IMPORTANT SAFETY RECALL

Safety Recall: NHTSA # 25V-847
December 2025

Jayco Inc. has decided that certain Model Year 2026 Entegra Coach Qwest, 2025-2026 Jayco Melbourne and Melbourne Prestige Class C motorhomes fail to conform to the requirements of Federal Motor Vehicle Safety Standard (FMVSS) number 120, "Wheels and Rims-Other Than Passenger Cars" and 49 CFR Part 567, "Certification."

The certification label below is only an example of the label you are to replace.

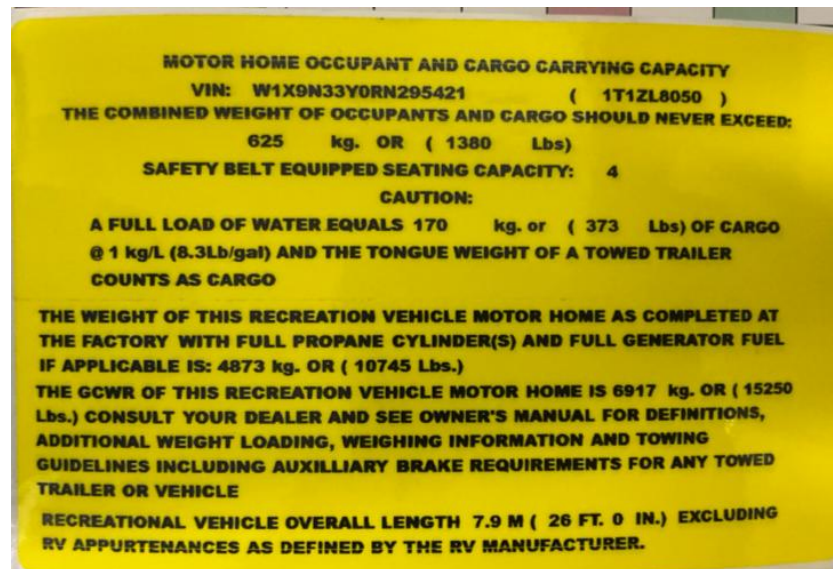
The Certification and Occupant and Cargo Carrying Capacity (OCCC) labels may list the incorrect Gross Vehicle Weight Rating (GVWR), Gross Axle Weight Rating (GAWR), and Gross Combination Weight Rating (GCWR). Incorrect weight information may lead to unintentionally overloading the vehicle, increasing the risk of a crash.

1. The location of the certification label is on the B'pillar. The location of the Cargo Carrying Capacity Label will be on the B'pillar and the entry door.
2. Remove the existing label. Using isopropyl alcohol and a shop rag, remove any adhesive residue from the surface where the original label was removed.
 - a. Allow the area to dry for at least 30 seconds.

1. Remove the protective back from the new label. Align the new label in the same location of the original label and apply it to the surface. Remove any air bubbles from the label.
 - a. Note: Do not attempt to remove or adjust the label once it has touched the surface. Doing so may damage the label or cause it not to adhere properly to the surface.
